SUNDRY NOTICE AND REPORTS ON WELLS

8. Well Name and No.
ROSA UNIT #94

**PLUGBACK and / or
PLUG AND ABANDONMENT PROCEDURE**

Re: Permanent Abandonment
Well: 94 Rosa Unit

Rosa Unit #94 **Proposed Plugback**

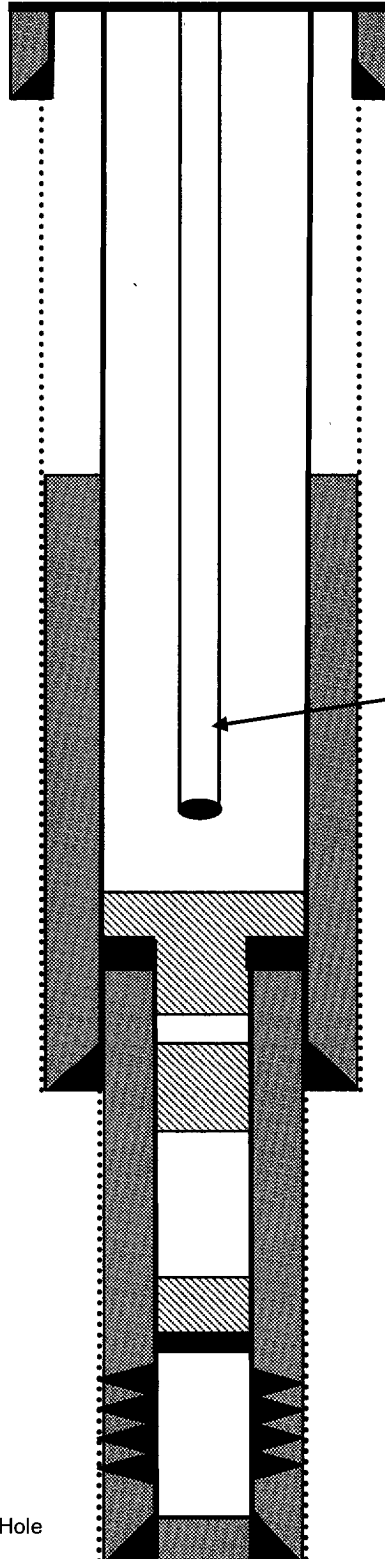
1. Plugging operations authorized are subject to the attached "General Requirements for Permanent Abandonment of Wells on Federal and Indian Lease."
2. Farmington Office is to be notified at least 24 hours before the plugging operations commence (505) 599-8907.
3. The following modifications to your plugging program are to be made:
 - a) Place a cement plug from 4151' – 4051' to cover the Chacra top.
 - b) Place the Pictured Cliffs/Fruitland plug from 3131' – 2806'.
 - c) Place the Kirtland/Ojo Alamo plug from 2552' – 2320'.
 - d) Place the Nacimiento plug from 1247' – 1147' inside and outside the 7" casing.

You are also required to place cement excesses per 4.2 and 4.4 of the attached General Requirements.
